How can we make Wimbledon Park Lake safe? Dave Dawson, November 2020

The proposed “Outline Design”

The Outline Design

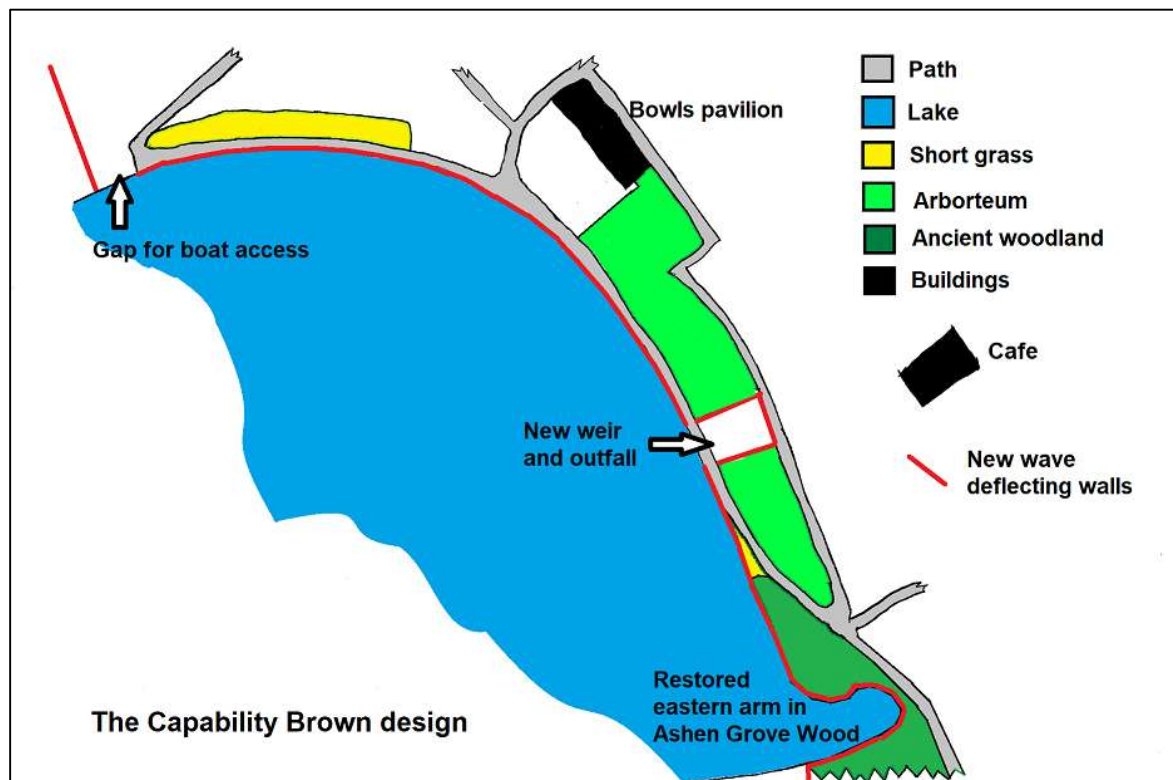
Assuming a much smaller flood, still requires a change that was rejected before, the **beheading of the lakeside piles and lowering of the lakeside pathway** between the Watersports building and the Stadium entrance. To make way, **four benches are to be relocated**.

Along most of the rest of the waterside, the path is to slope up to a kerb on the side away from the lake. This kerb is to be much lower than was required in the Flood Study, but it still requires **at least eight ramps to allow people and boats to get to and from the lakeside**.

Although lowering the lake would restore Brown's design and would help greatly with flood storage and with drainage upstream, **the lake is not to be lowered**.

Only one aspect of the Flood Study option remains: **a huge new outfall is to be constructed in the ancient Ashen Grove Wood. This would destroy much of an irreplaceable asset.**

The design is silent on how the flood flows are to pass sensibly and safely through the public park

The *Capability Brown Design*, developed by the Friends, overcomes the difficulties. It restores the lake to its historic level and keeps the precise lines of Brown's 18th century carriage drive, now the lakeside walk. Flooding problems upstream are eased. Access for people and boats is unimpeded. This is achieved by a low wave-deflecting wall along the whole length of the dam. A new, high capacity, Brownian cascade replaces the waterfall. Ancient woodland and trees are kept and the threatened Eel can return safely from the Sargasso Sea. The eastern arm of the lake is restored.

If the new, much lower, flood assumed in the Outline Design is correct, the Capability Brown design becomes even easier to implement. The outfall needs not be so complex and the lakeside wall can be much lower.
